Change No. 12
License No. DPR-28

SAFETY EVALUATION BY THE DIRECTORATE OF LICENSING

VERMONT YANKEE NUCLEAR POWER CORPORATION

CHANGE NO. 12 TO THE TECHNICAL SPECIFICATIONS

Figure 3.5.1 Maximum Allowable Planar LHGR

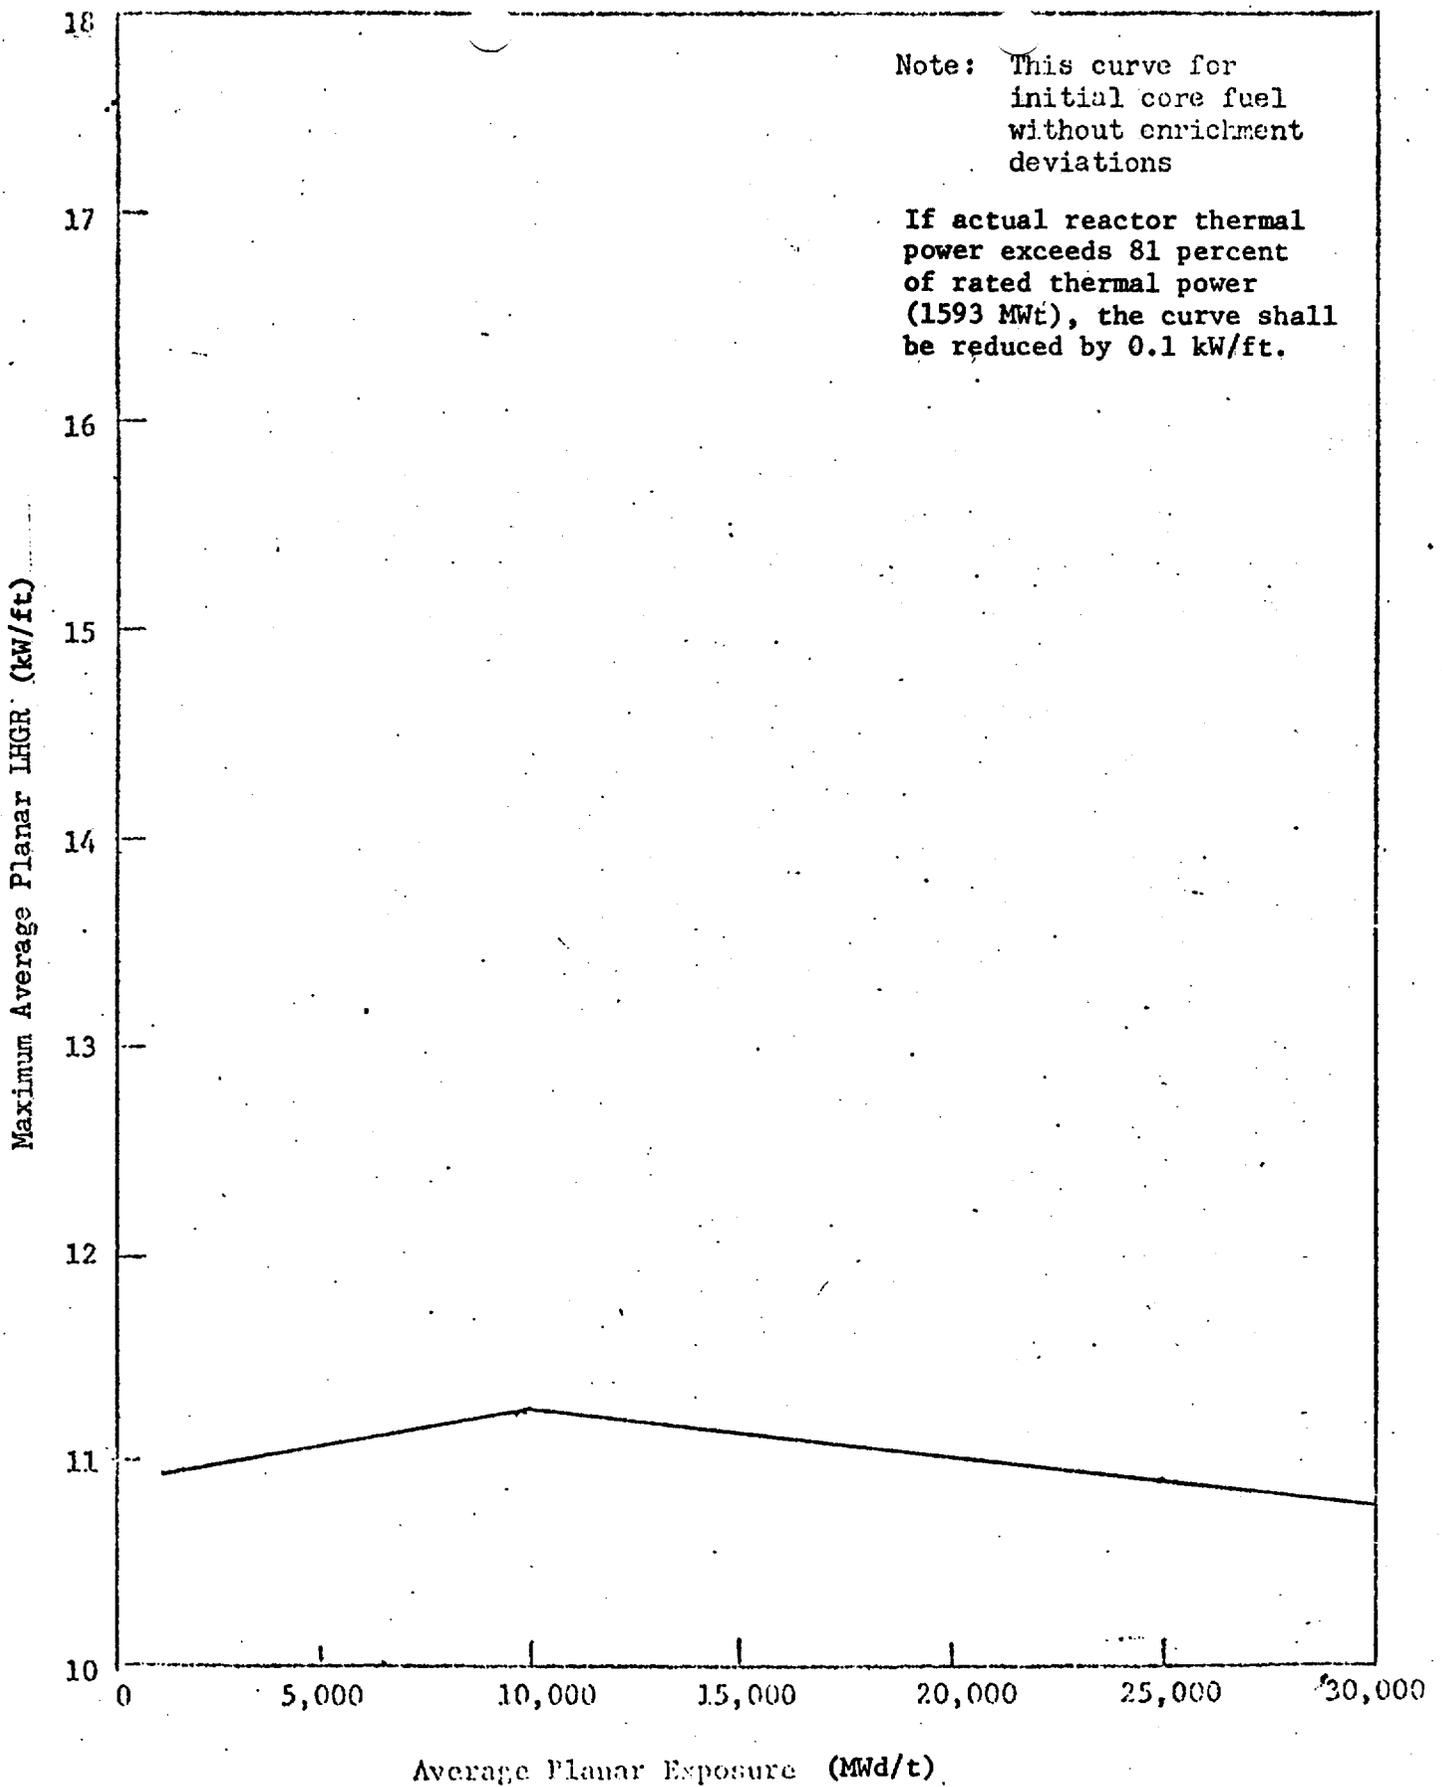
The MAPLHGR curves for the initial core fuel with and without enrichment deviations are based on computer calculations out to 30,000 Mwd/t exposure as requested by our October 26, 1973 letter. The MAPLHGR curve for the reload-1 fuel assemblies are based on computer calculations with an assumed fuel planar average exposure of 10,000 Mwd/t but have been extrapolated for higher exposures. Since the reload fuel assemblies will not be depleted to an average exposure greater than 10,000 Mwd/t during the next operating cycle, the proposed curve is acceptable for this operating cycle. A revised MAPLHGR graph for the reload fuel assemblies, based on detailed heat up calculations at higher burnups, will be required for operation beyond this operating cycle.

Accordingly, pursuant to Section 50.59 of 10 CFR Part 50, the Technical Specifications appended to Facility License No. DPR-28 are hereby changed by replacing Figures 3.5.1 and 3.5.1A with the enclosed revised figures dated November 6, 1973, and by adding the enclosed Figure 3.5.1B.

We have evaluated the proposed changes to the maximum average planar linear heat generation rate (MAPLHGR) curves in the Technical Specifications. We have concluded that these MAPLHGR curves were determined using the Interim Acceptance Criteria calculational model, including the effects of fuel densification, and use of these MAPLHGR curves will not result in a peak clad temperature in excess of 2300°F during the loss-of-coolant design basis accident. Therefore, the Interim Acceptance Criteria will be satisfied during operation of the reactor in the proposed manner. The MAPLHGR curves are based on computer calculations out to 30,000 MWd/t exposure as requested by our October 26, 1973 letter for the initial core fuel with and without enrichment deviations. The MAPLHGR curve for the reload fuel is based on computer calculations out to 10,000 MWd/t exposure since the reload fuel will not be depleted to average exposure greater than this during the next operating cycle. Since the reanalysis to determine the MAPLHGR curves was based on a rated thermal power level of 81 percent or less, the proposed figures have been modified by adding a note to the figures in the Technical Specifications stating that the MAPLHGR curves must be reduced by 0.1 kW/ft if the stated power level is exceeded.

OFFICE	or less, the proposed figures have been modified by adding a
SURNAME	note to the figures in the Technical Specifications stating that the
DATE	MAPLHGR curves must be reduced by 0.1 kW/ft ² if the stated power level
	is exceeded. is

Figure 3.5.1.B Maximum Allowable Planar LHGR

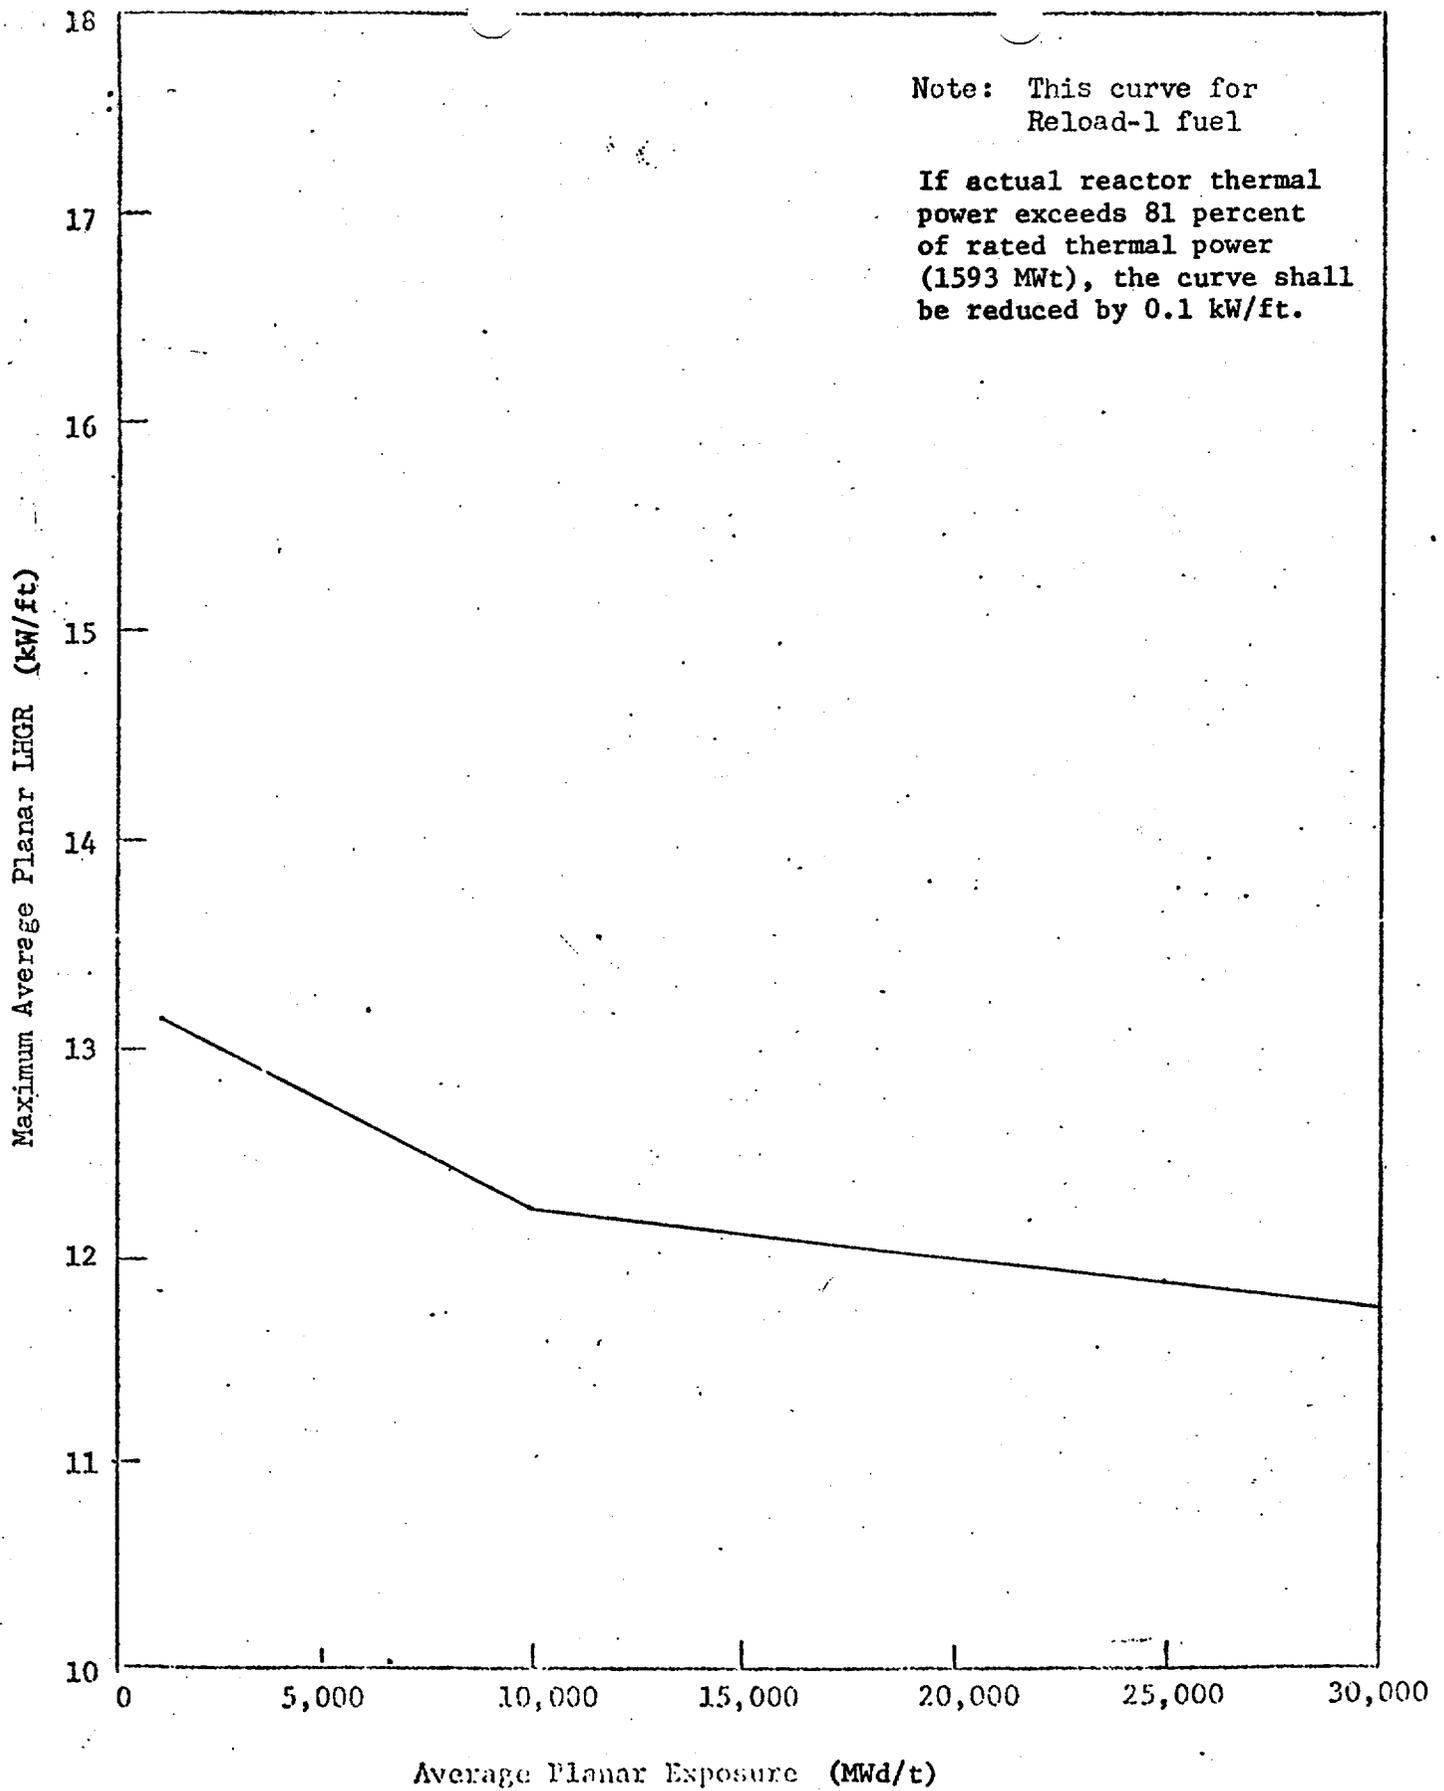
The MAPLHGR curves are based on computer calculations out to 30,000 MWd/t exposure as requested by our October 26, 1973 letter for the initial core fuel with and without enrichment deviations. The MAPLHGR curve for the reload fuel ~~is~~ based on computer calculations out to 10,000 MWd/t exposure since the reload fuel will not be depleted to average exposure greater than this during the next operating cycle. Since the reanalysis to determine the MAPLHGR curves ~~was~~ based on a rated thermal power level of 81 percent
